## EXHAUST SYSTEM UPDATE

**2020 1290 SUPER DUKE R**  
**2021 1290 SUPER DUKE R**  
**2022 1290 SUPER DUKE R EVO**  
**2023 1290 SUPER DUKE R EVO**

#### INITIAL INFORMATION:

Fig. 3 – Protecting the radiator

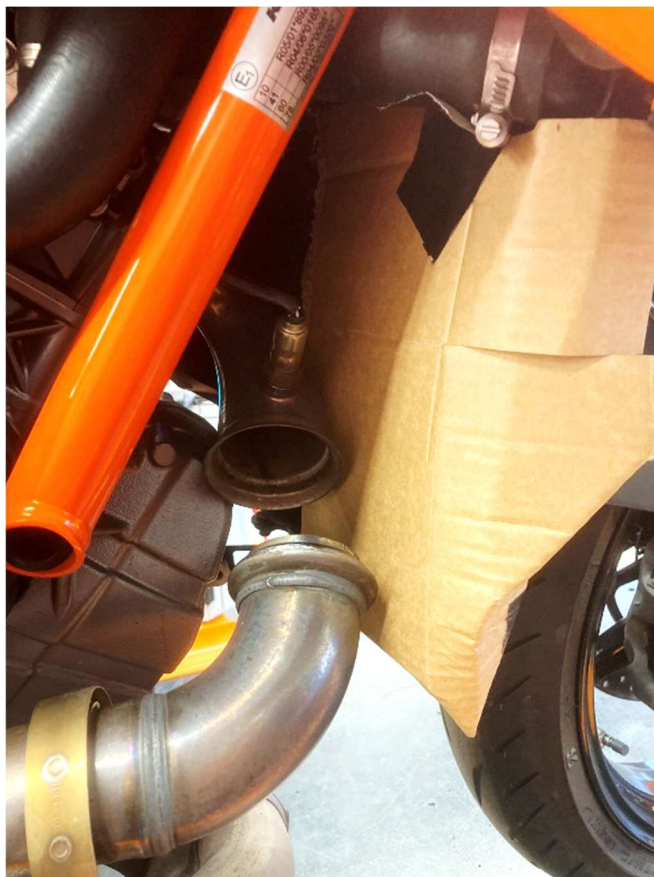
1. Dismantle the rear silencer according to the repair instructions.
2. Protect the cooler against damage with cardboard, see Fig. 3.

Fig. 5 – Position of V-clamp D=70.1

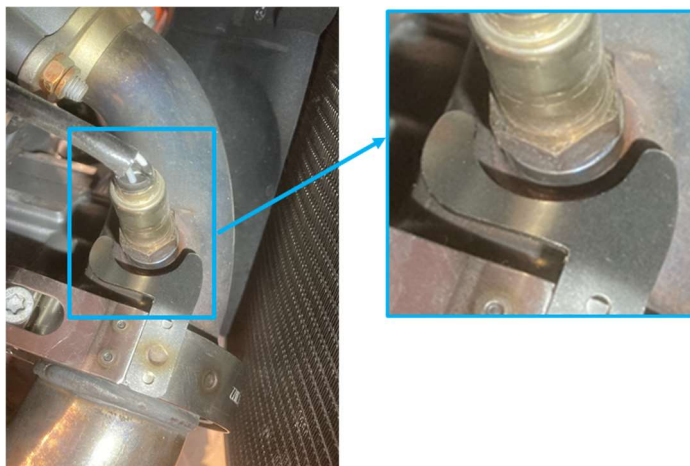
4. Fit the header gasket (#61705005105).
5. Fit the V-clamp D=70.1 (#61705058200) so that the anti-rotation device does not touch the flange of the lambda sensor, see Fig. 5.

Fig.6 – Locking plate and nut

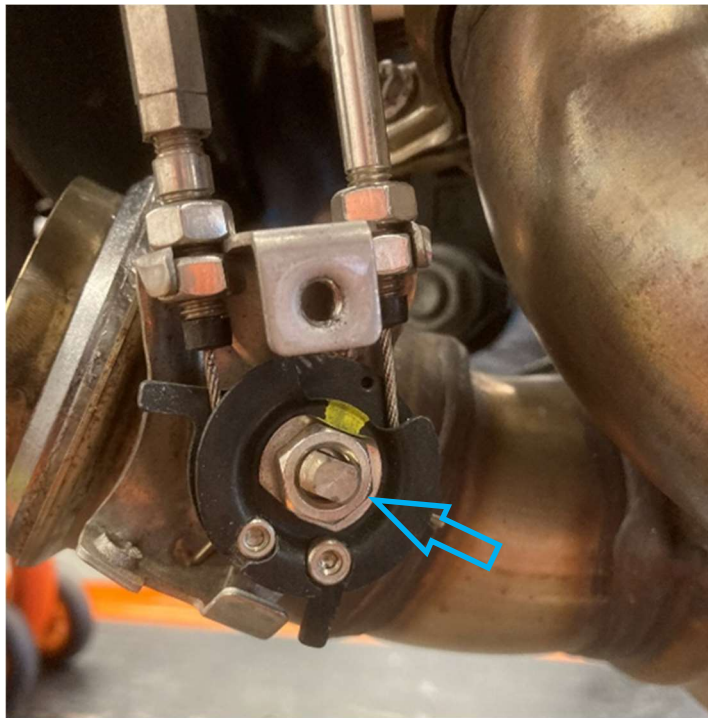
1. Remove the exhaust flap locking plate and nut, see Fig. 6 and Fig. 7.

Fig.8 – Replacing the torsion spring.

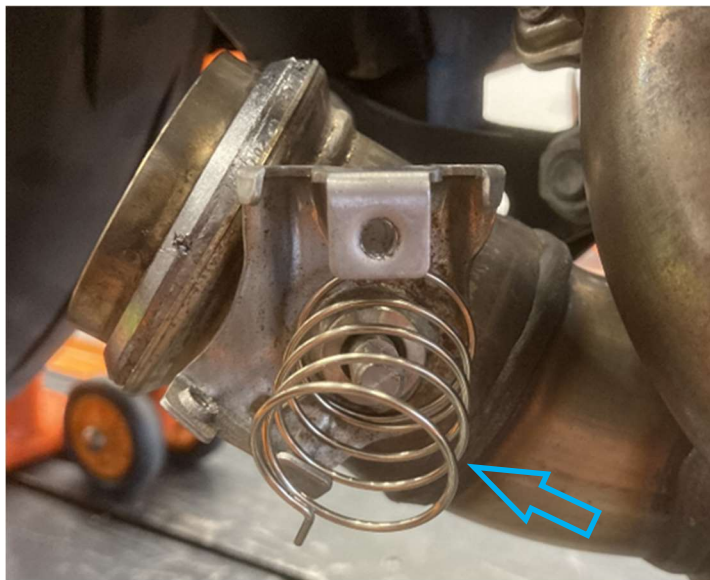
2. Replace the installed torsion spring of the exhaust flap control with the new torsion spring included in repair kit #A62405031044, see Fig. 8.

Fig.9 – Locking plate and nut refitted

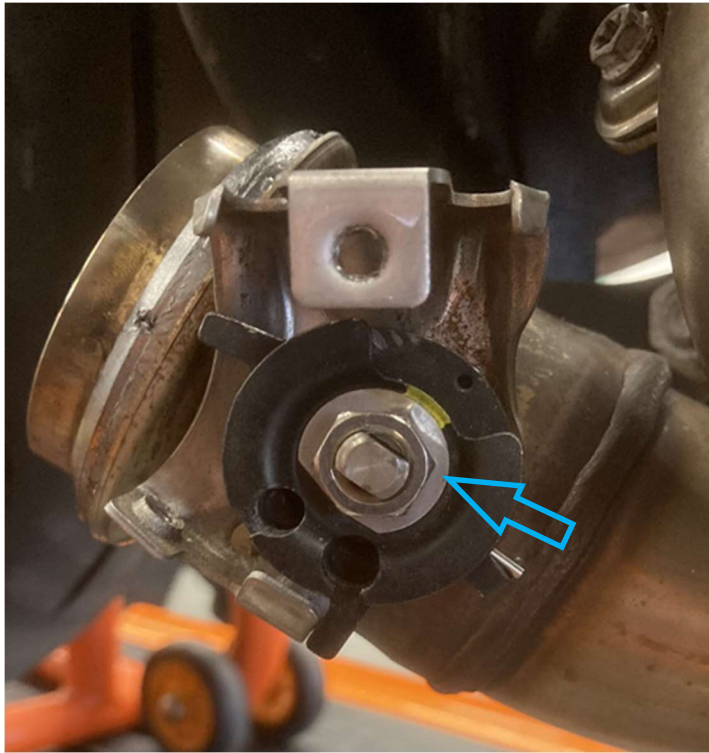
- Fit the new lock washer and tighten the nut to the specified torque (Table 2), see Fig. 9.

Fig.10 – Adjusting screw with wrench size 8 mm for cable tension

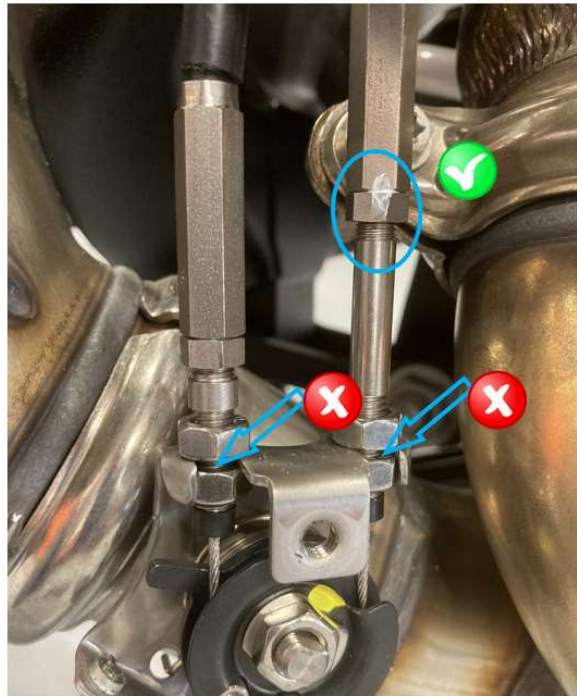
To adjust the cable tension, use only the adjusting screw with a width across flats of 8 mm as shown in Fig. 10.
